CR102 State of Washington changes not previously covered (State of Washington Existing Amendments Report)

Note: Most of these State of Washington changes reflect the State's choice to adopt the 2024 model code section in lieu of a 2021 Washington State Amendment. The State and Seattle often "pre adopt" future model code amendments. When the model code changes are finally incorporated into the model code edition, the pre adopted amendments need to be removed; there is no change in the technical code requirements. The "bolded" text have technical changes or are relocations and will be discussed. We will discuss some but not all of these changes because they are "editorial" in our CCAB meeting. Certainly, if you have questions about any of these we can discuss them.

Figure 1208.4

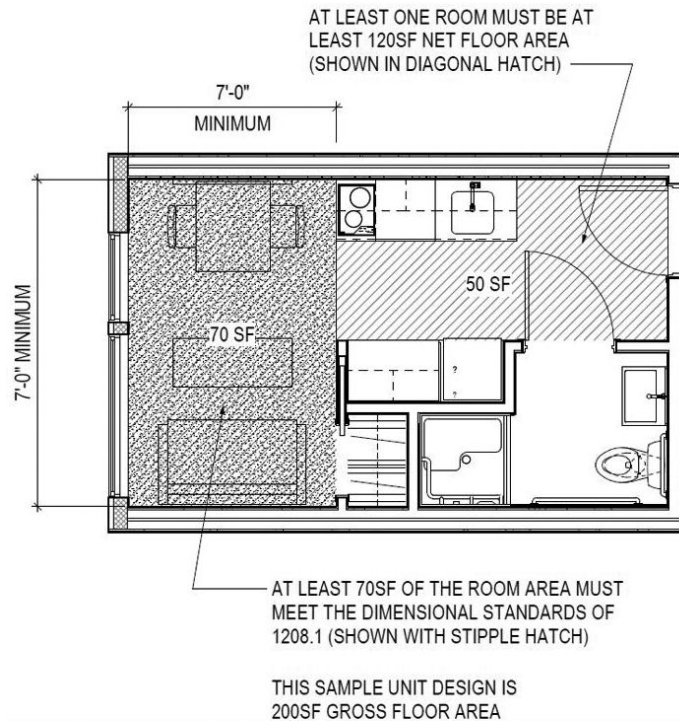
1208 Dwelling unit size

[W] 1208.1 Minimum room widths. *Habitable* spaces, other than a kitchen, shall be not less than 7 feet (2134 mm) in any plan dimension. Kitchens shall have a clear passageway of not less than ~~((3 feet (914 mm)))~~ 30 inches between counter fronts and appliances or counter fronts and walls.

[W] ~~((1208.3 Dwelling unit size. Dwelling units shall have a minimum of 190 square feet (17.7 m2) of habitable space.))~~ Not adopted.

[W] 1208.4 Room area. Every *dwelling unit* shall have not less than one room that shall have not less than 120 square feet (11.2 m2) of *net floor area*. *Sleeping units* ~~((and other habitable rooms of a dwelling unit))~~ shall have a *net floor area* of not less than 70 square feet (6.5 m2).
